Subject: AP1000 Response to Request for Additional Information (SRP6.2.2)

AP1000 TECHNICAL REPORT REVIEW**Response to Request For Additional Information (RAI)**

RAI Response Number: RAI-SRP6.2.2-CIB1-31
Revision: 1

RAI Response Number: RAI-SRP 6.2.2-SPCV-25
Revision: 2

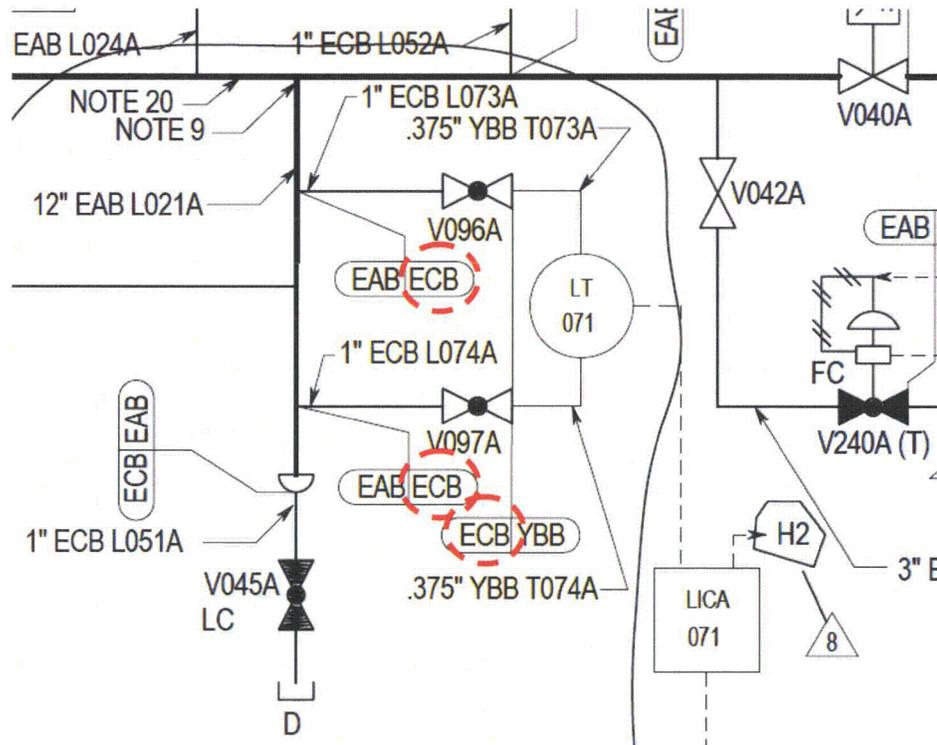
Change:
All highlighted line classes to be changed to 'CBB'

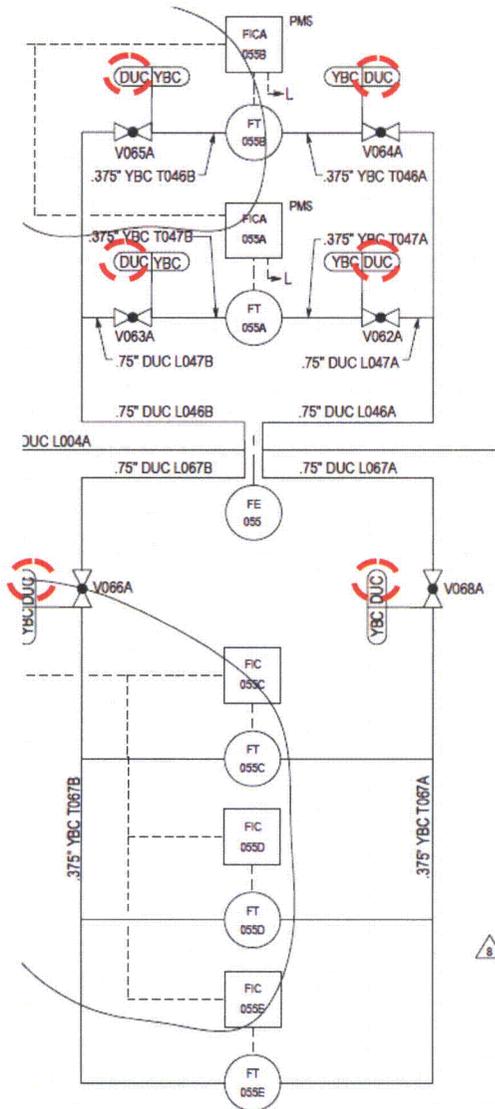
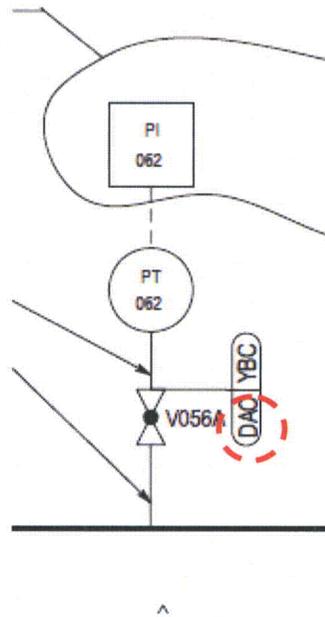
Change:

All highlighted line classes to be changed to 'CBC'
